FILE P. I. No. 0008625, Fulton County
CSMSL-0008-00(625)
SR 400 Noise Barriers from Northland Drive to Glenridge Connector

SUBJECT APPROVED REVISED PROJECT CONCEPT REPORT

SUBJECT **Revised Project Concept Report**

REVISED PROJECT CONCEPT REPORT

STATE OF GEORGIA
DEPARTMENT OF TRANSPORTATION
OFFICE: URBAN DESIGN
TYPICAL SECTIONS
S.R. 400 NOISE BARRIER

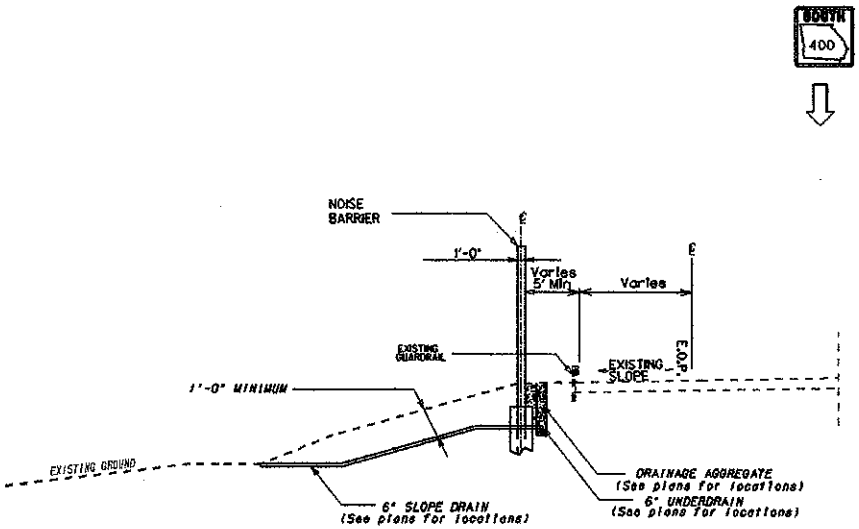
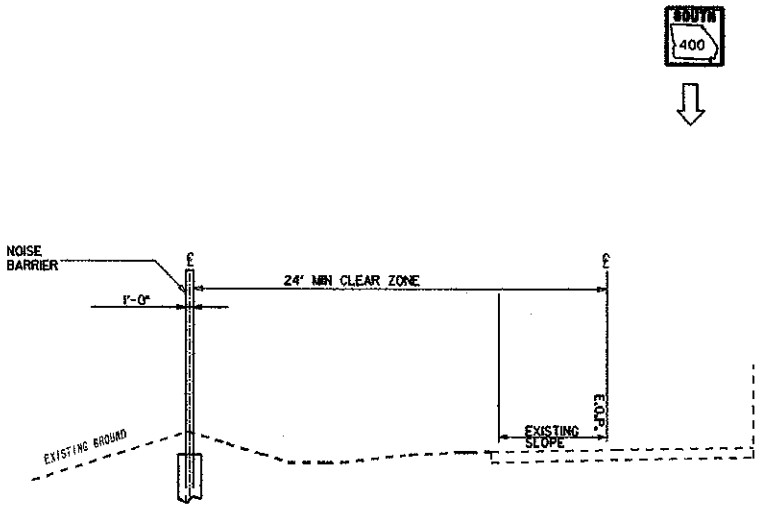
The approved typical section maintains the existing 16-foot lane ramp with paved shoulder that varies from 5 to 10 feet and adds v-gutter and guardrail with the noise barrier 5 feet from the face of the guardrail.

The proposed typical section will maintain the existing 16 feet lane ramp with paved shoulder that varies from 5 to 10 feet.

1.) Existing guardrail location will be maintained and noise barrier will be set at a minimum of 5 feet from face of guardrail.
2.) Where no guardrail exists, the noise barrier will be located outside of the clear zone.
